Jasper Water Treatment Plant Rehabilitation

City of Jasper, Georgia

Addendum No. 2 Date: October 9, 2025

CLEARWELL IMPROVEMENT PLAN SHEET NUMBER

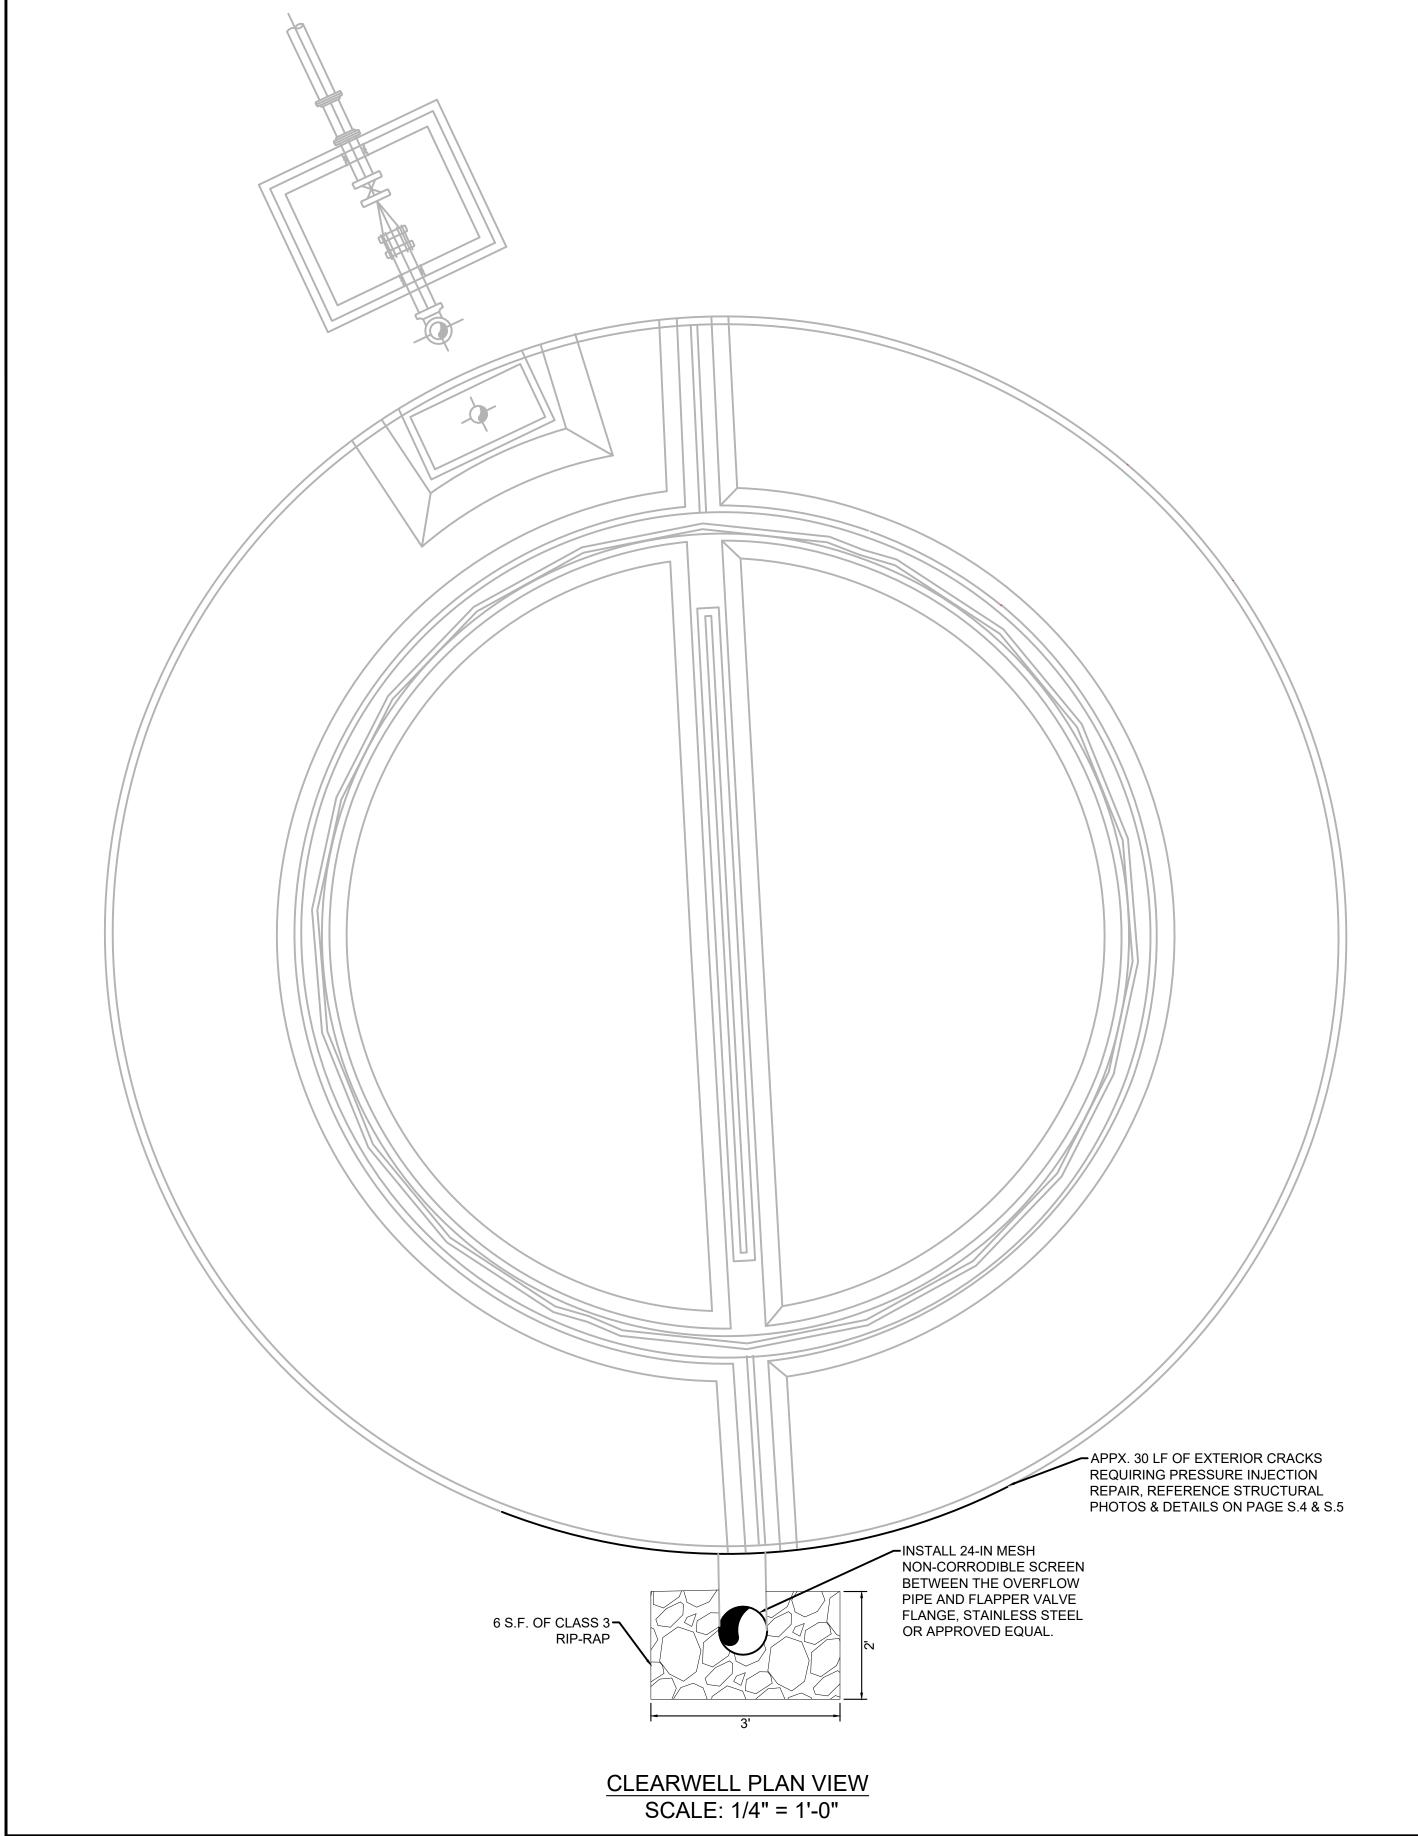
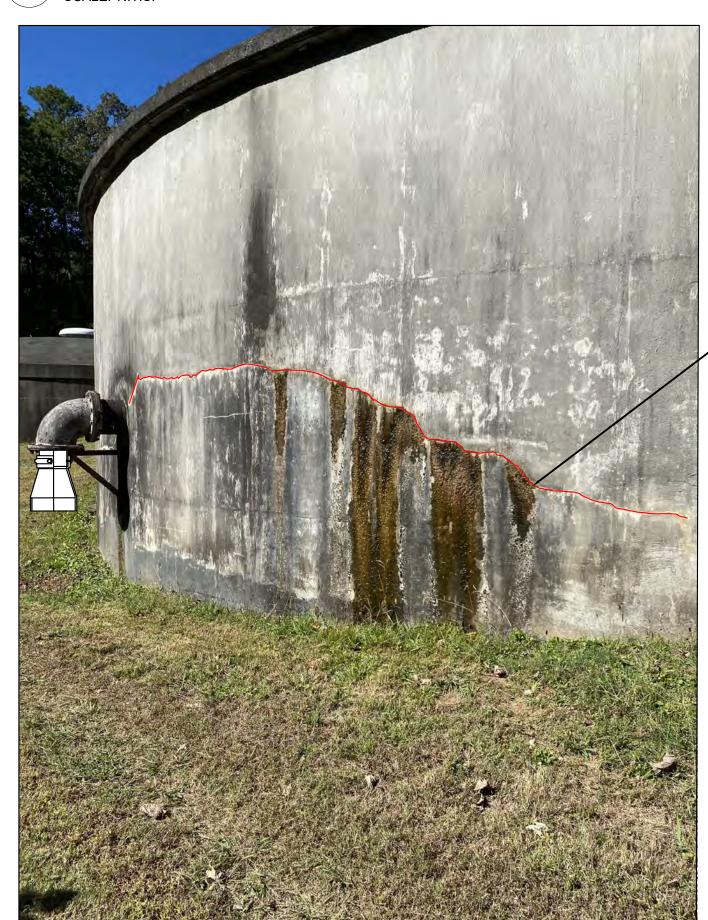
Clarified duckbill flapper valve.

INSTALL 24" DUCK
BILL FLAPPER VALVE
OR APPROVED EQUAL
